## **Appendix G: RFLMA Contact Records**

## **Contact Record 2008-01**

## ROCKY FLATS SITE REGULATORY CONTACT RECORD

**Purpose:** Completion of Additional Ecological Sampling in accordance with RFLMA Attachment 2, Table 5

1  
2 2 SEEP NO. 7 PLAN

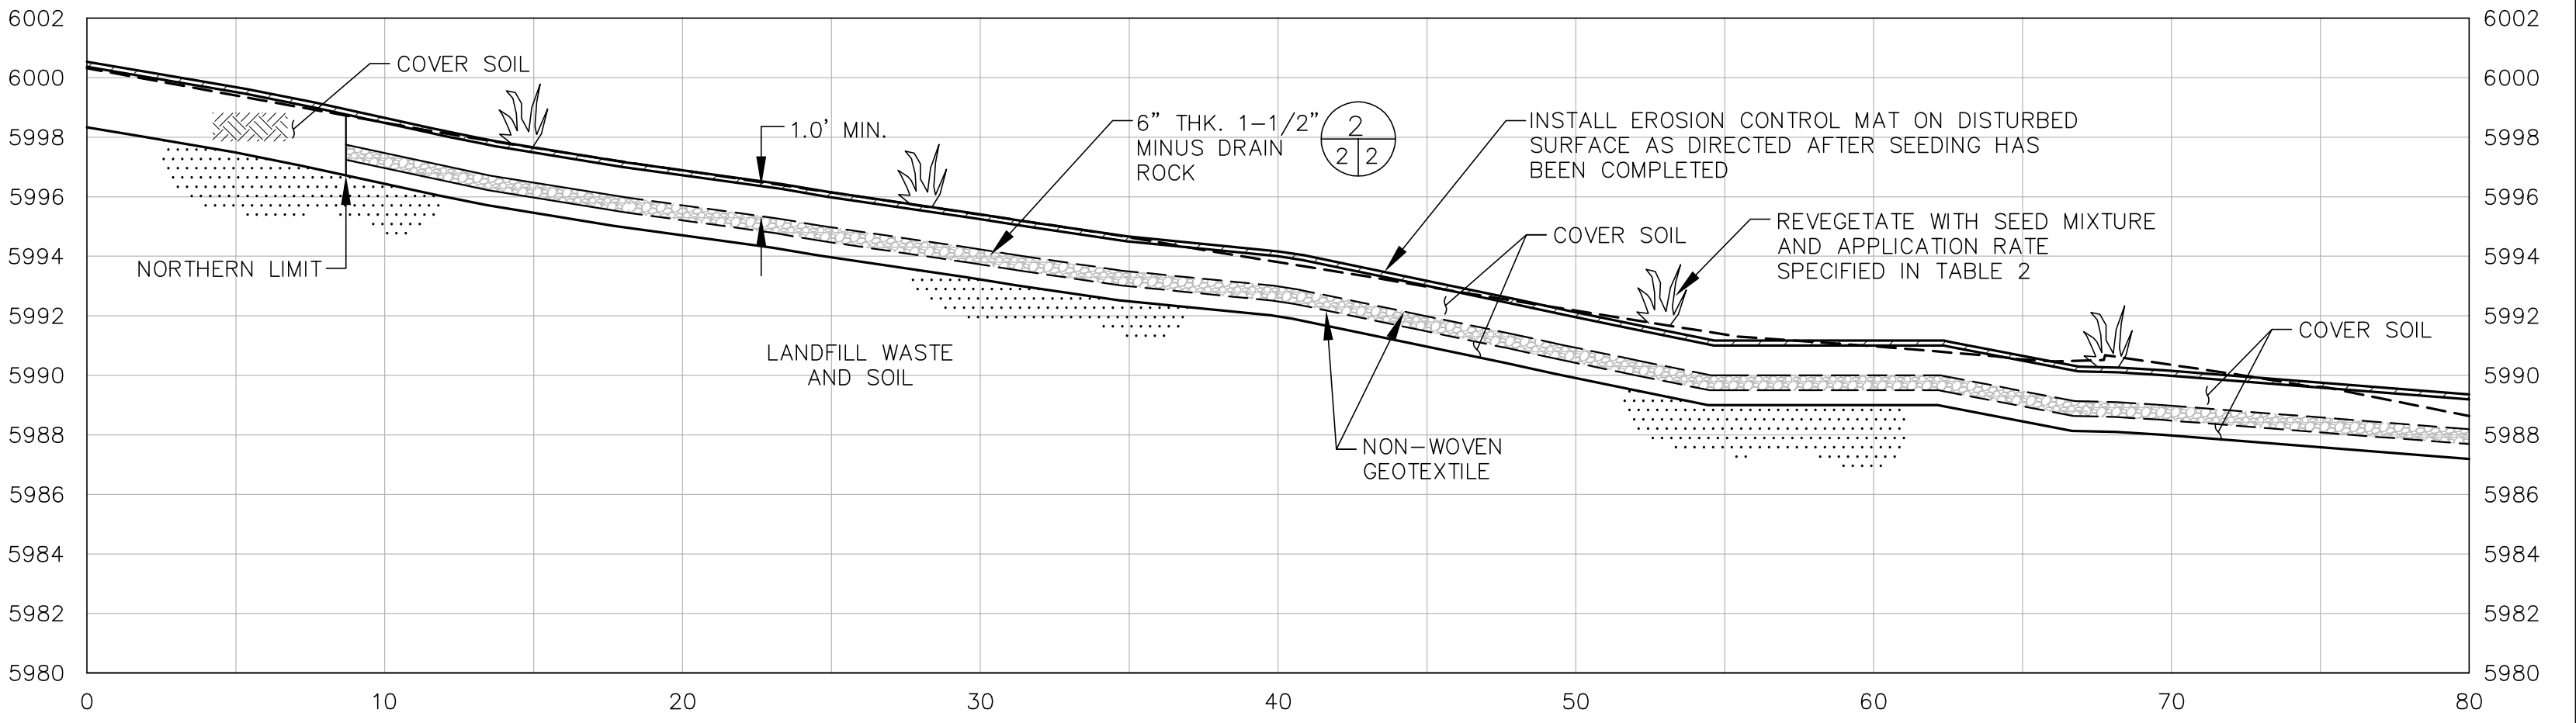
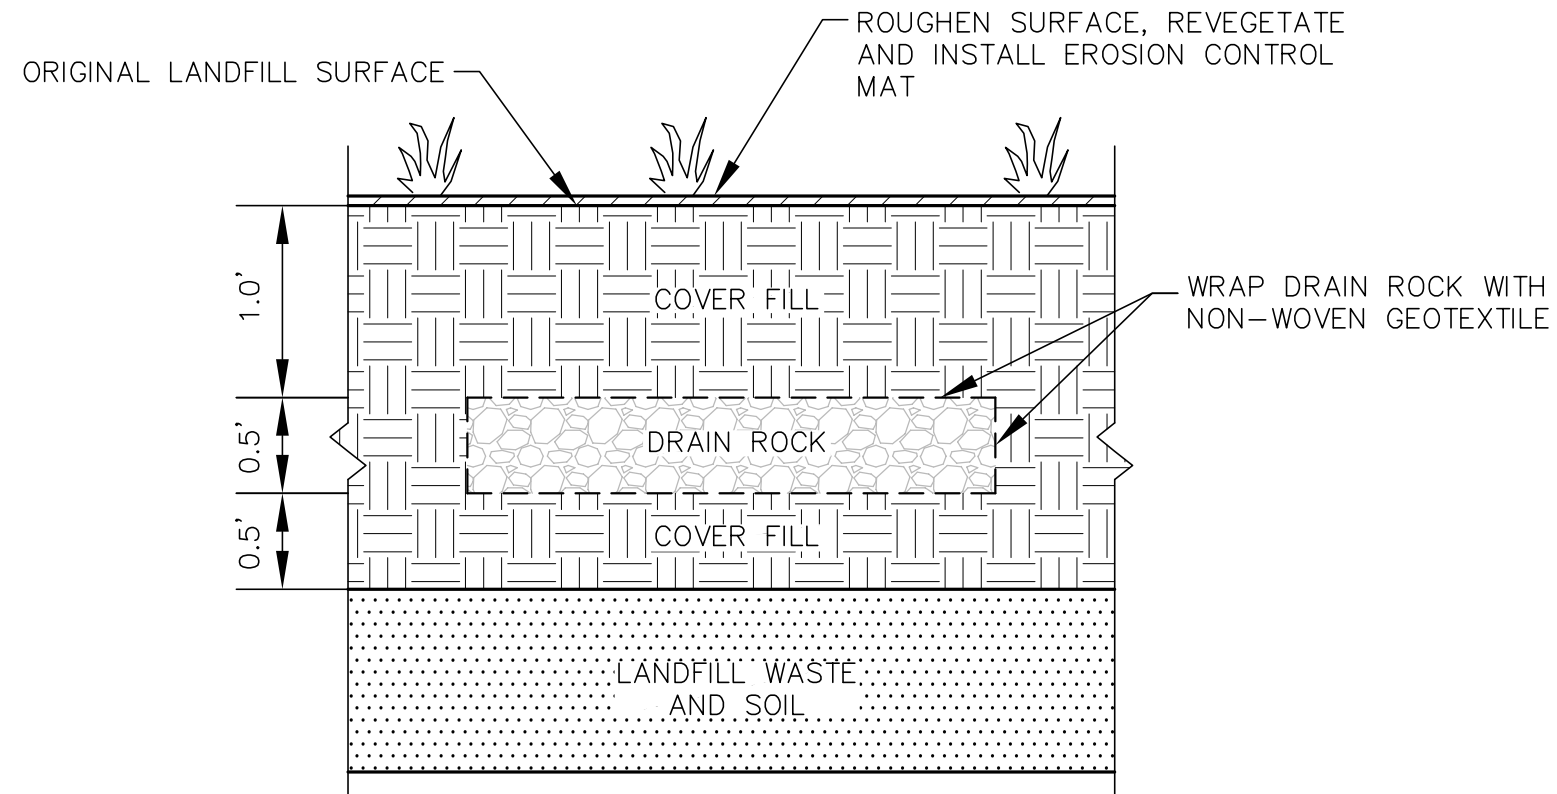
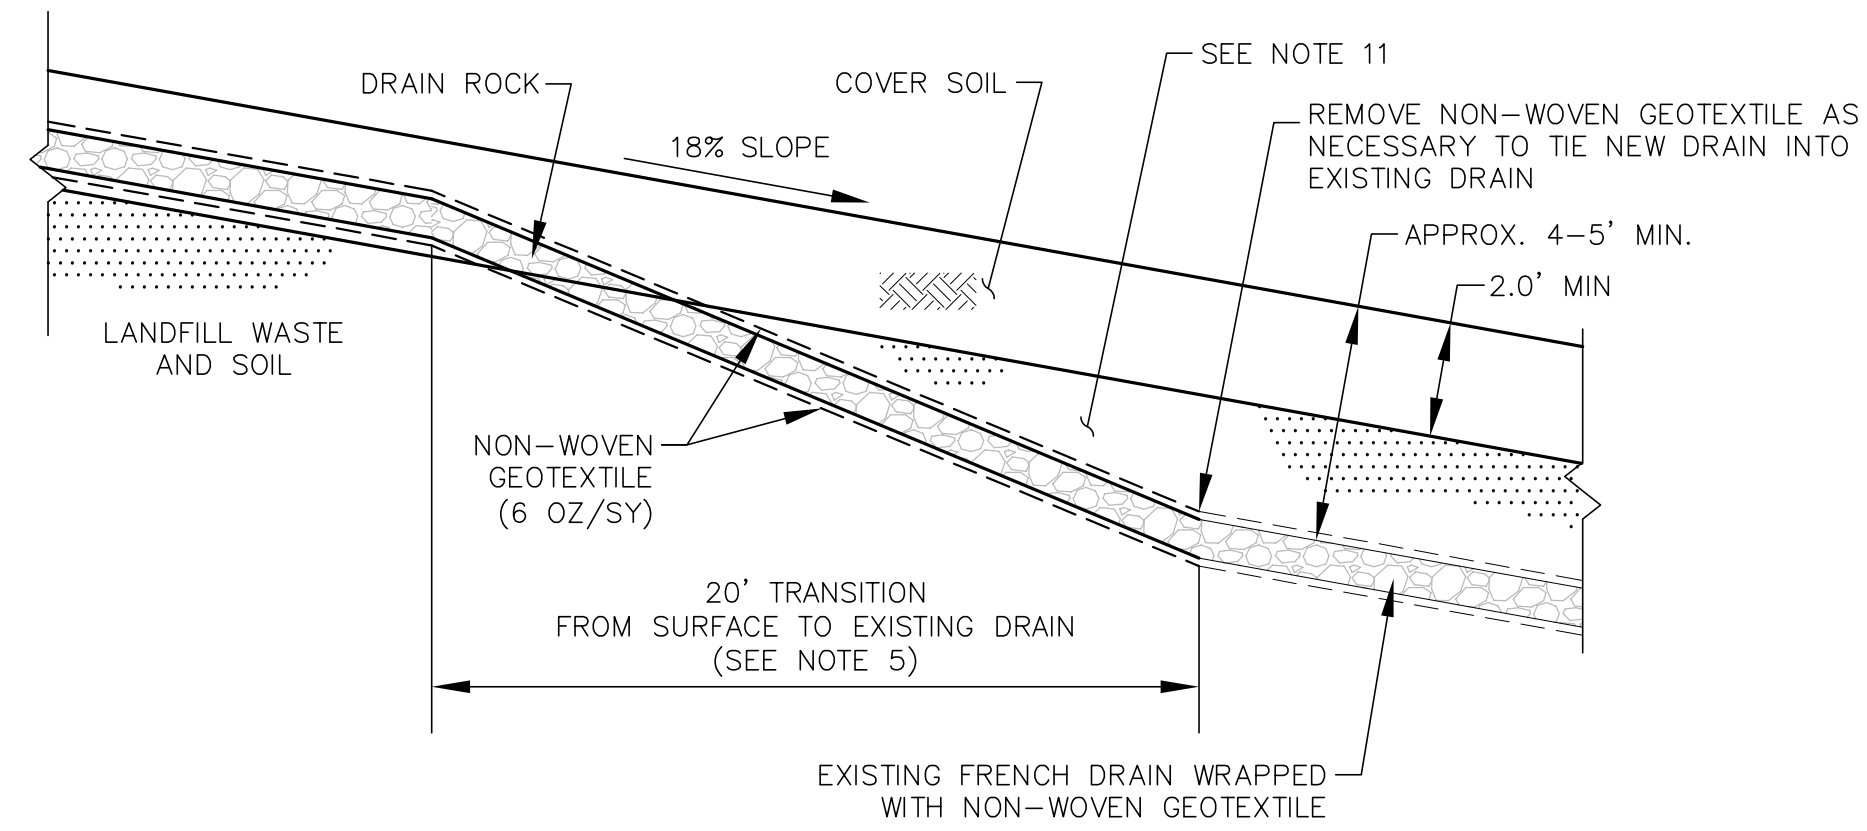
3. Seep 7 drain extension – An extension to the current drain will be installed upgradient within the 2-foot cover depth in the general area where this seep has expressed (“day lighted”) on the surface and resulted in saturation of surface soil. This will be carefully constructed in the cover layer so as not to intrude into the underlying soil/waste. At its southern end, the excavation will extend below the cover material for a short distance to a depth of 4 to 5 feet to tie into the existing drain. Figure 2 shows the conceptual design for the drain extension.

The OLF M&M Plan will be modified to document the drain extension, including updating the drawings to show the location.

Figure 1: Excerpt of engineering drawing no. S04362-R02-F01-D+, showing collection sump and associated components.

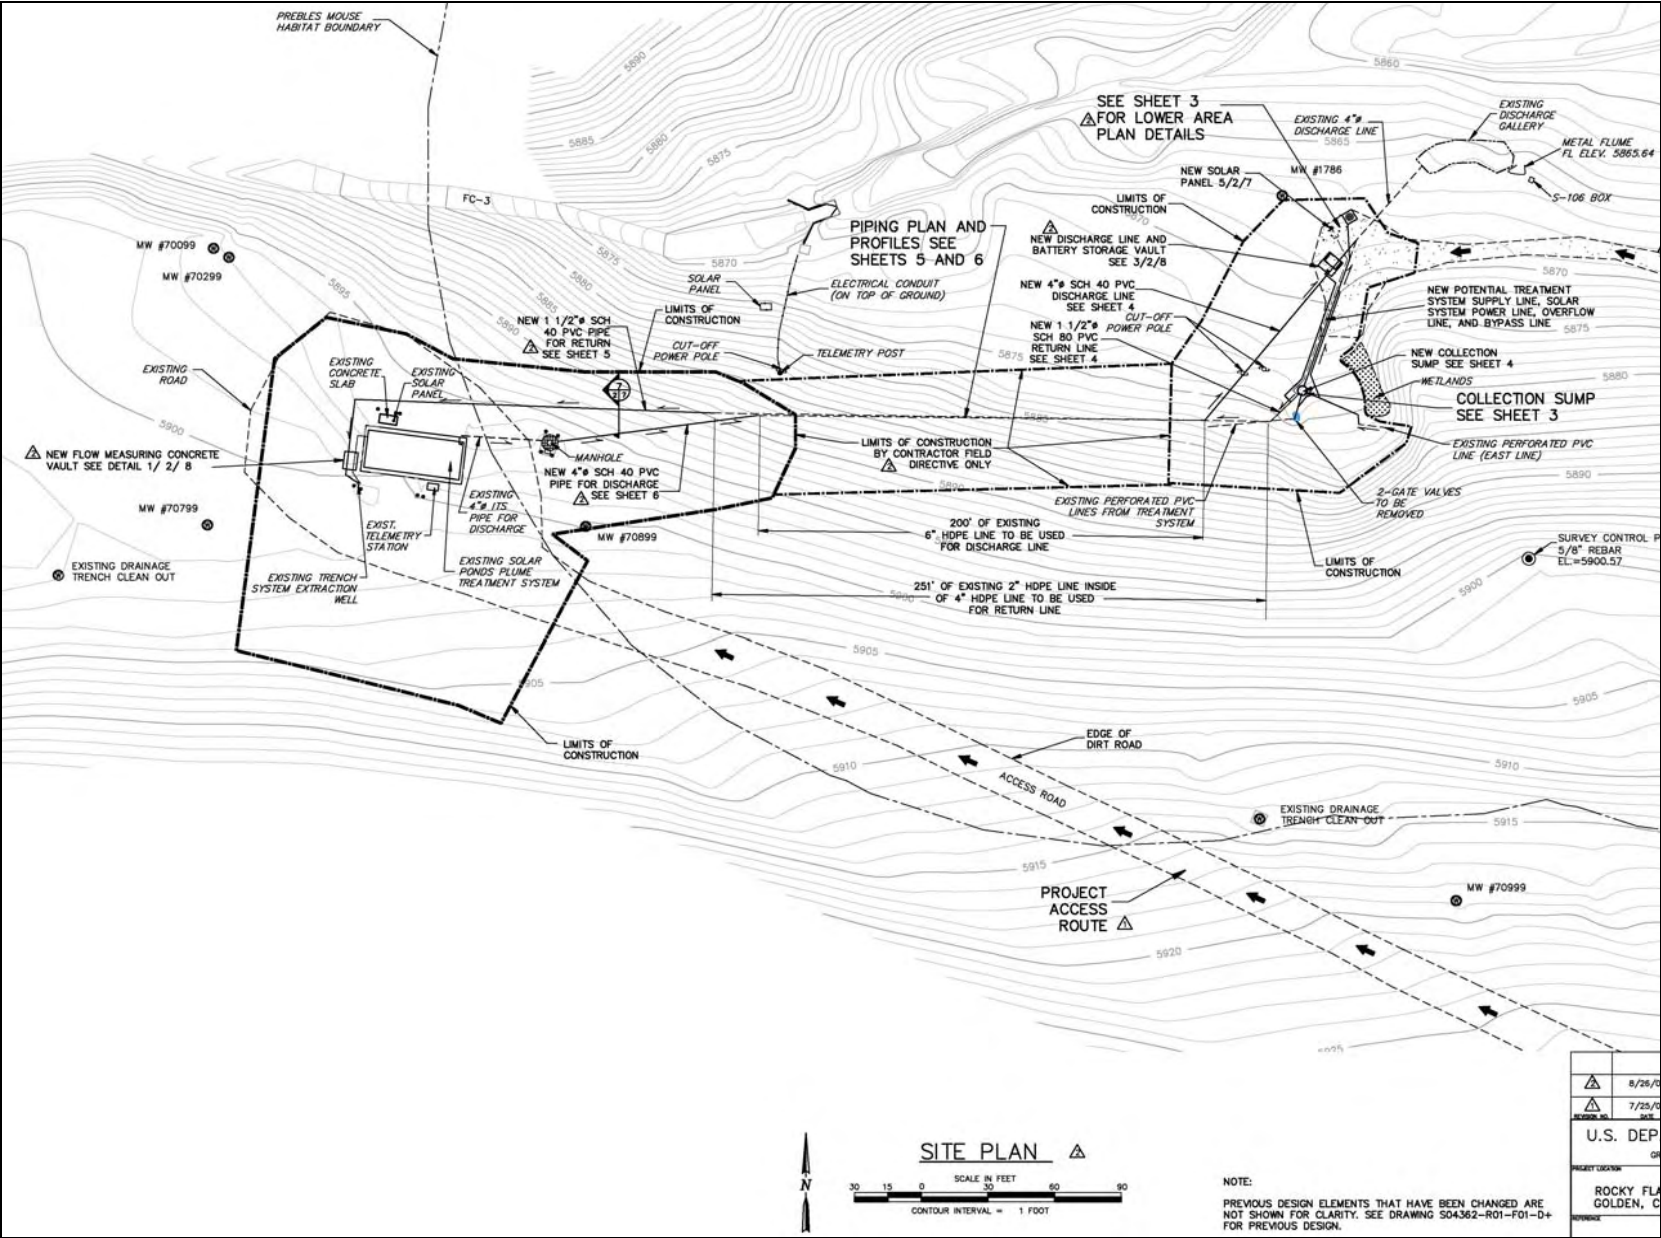
Included in this work will be the installation of the necessary plumbing, flow measurement, pump, and electrical power (solar) to support the proper operation and maintenance of the sump. Figure 1 is a conceptual drawing showing the locations of the main components of the collection sump and transfer piping. Final construction drawings have been submitted to CDPHE for approval.

Pursuant to RFLMA paragraph 66, DOE and CDPHE do not consider addition of the collection sump and transfer of collected water to the treatment cell to constitute a significant change from existing requirements of RFLMA, and this Contact Record shall be used to provide public notice of these modifications to the SPPTS.

**Figure 1. Time-series plot of analytical data from Table 1 together with calculated regression best-fit trend and corresponding R<sup>2</sup> value.**

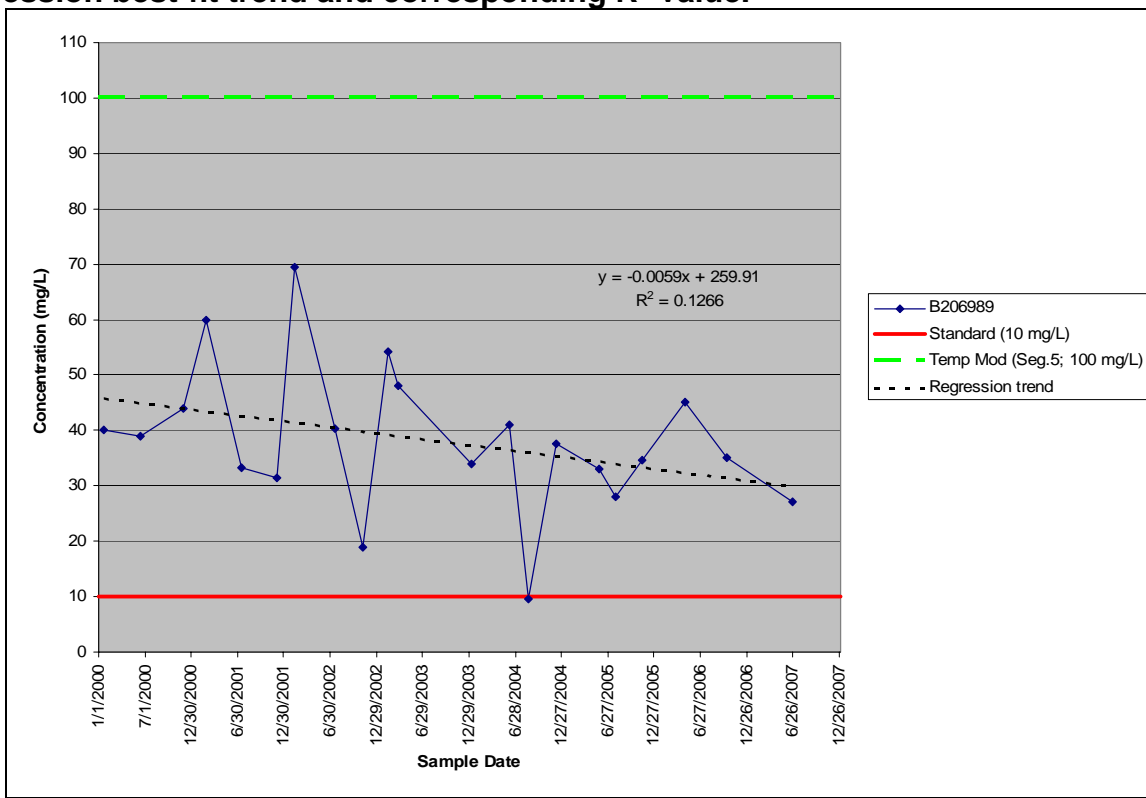
Figure 1 presents these data in a time-series plot, and includes a best-fit regression trend line. The  $r^2$  value, 0.1266, suggests the fit is not particularly good. This is to be expected given the variability of the data. Even so, the visually apparent overall decrease is confirmed.

**Figure 2. Plot of analytical data from Table 1 together with calculated Seasonal-Kendall trend.**

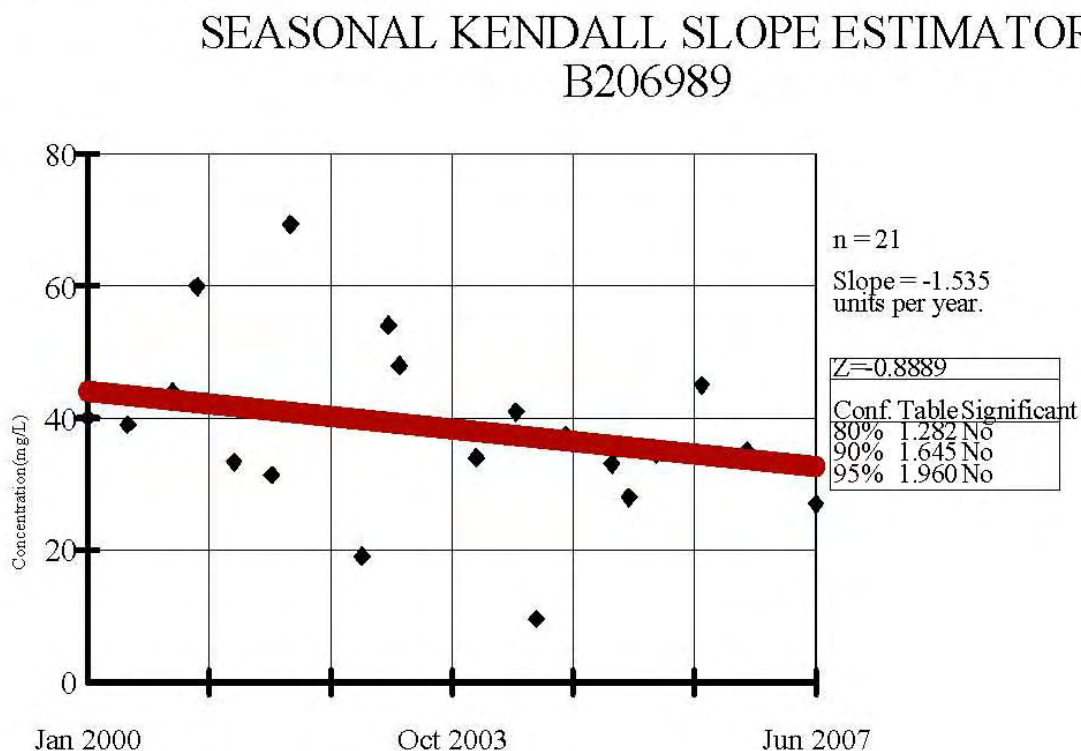
Figure 2 shows the same data, but includes a trend calculated using the Seasonal-Kendall trending method. Once again, a decreasing trend is evident. But again, the statistical confidence is not high; as shown, the trend does not meet an 80% level of significance.
